**RE: Winrock Redevelopment Dave and Busters
Grading and Drainage Plan
Engineers Stamp Date 9/10/14 (J19D038)**

RE: **Winrock Redevelopment Dave and Busters**
Grading and Drainage Plan
Engineers Stamp Date 8/14/14 (J19D038)

GRADING AND DRAINAGE PLAN

Dave & Busters

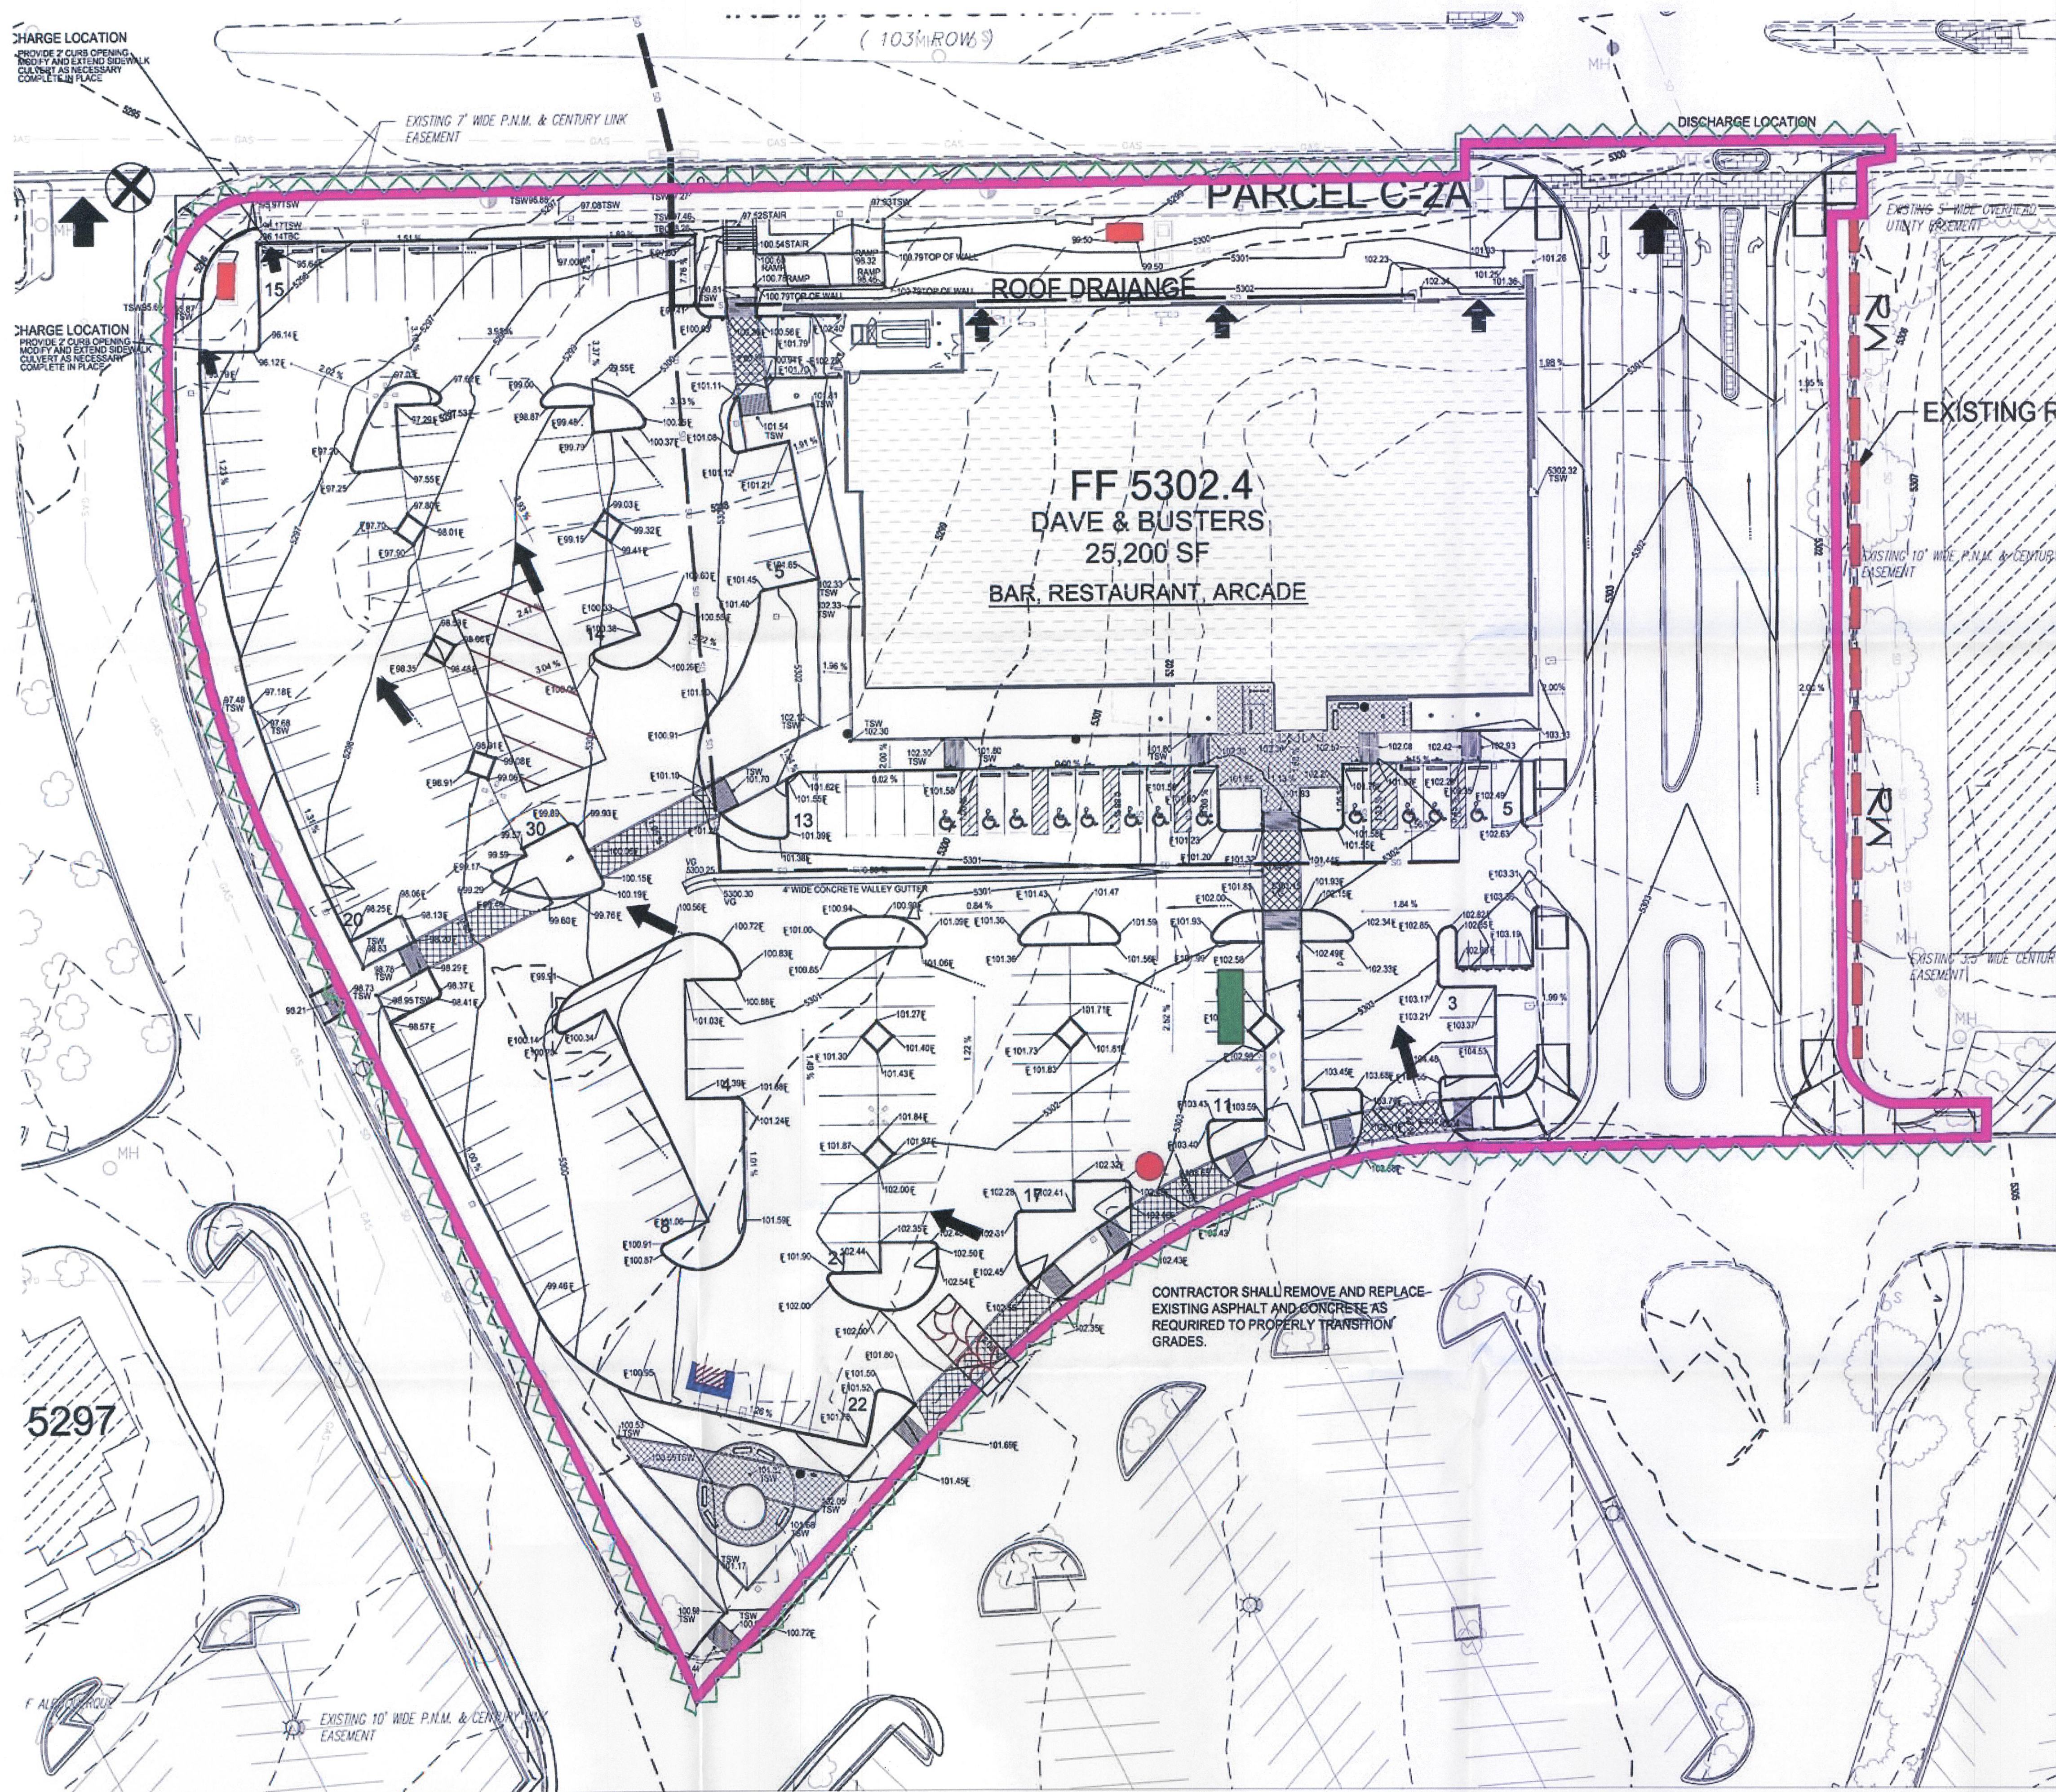
- 1) There appears to be a curb across the new access to the road along the west property boundary. This seems to be a drafting error that needs correction.
- 2) If the road along the west property boundary becomes public in the future, a valley gutter will be required at the west access

1. Regarding the parking islands on the southwest corner: It is not clear whether new parking islands are being built or if striping only. Contour lines extend though these islands, but a return curb would typically be required. - *Noted for future work, SE 9.12.14*

2. Detail all proposed islands along on south side of roadway/driveway showing spot Flowline Elevations. ✓
3. Show a valley gutter and flowline elevations at the new curb returns at the new access. Label streets. - *Project will require reconfigure area in the future, SE 9.12.14*

4. The Flowline Elevations on the parking islands are offset. It appears that the drafting layers are not correctly aligned. ✓
5. I understand that the parking and traffic circulation were amended through an administrative amendment, but there seems to be a discontinuous pedestrian path though the parking island along at the south side of the new access.

6. If the Site Plan is being amended, do the drainage basins delineated on Site Plan SDP-6 (stamp date 10-3-13) still apply to this new condition? *Additional information included, SE 9/12/14*

7. A new ESC Plan will be needed with this amendment to the G&D plan. *- Construction is nearly complete. SE 9/12/14*
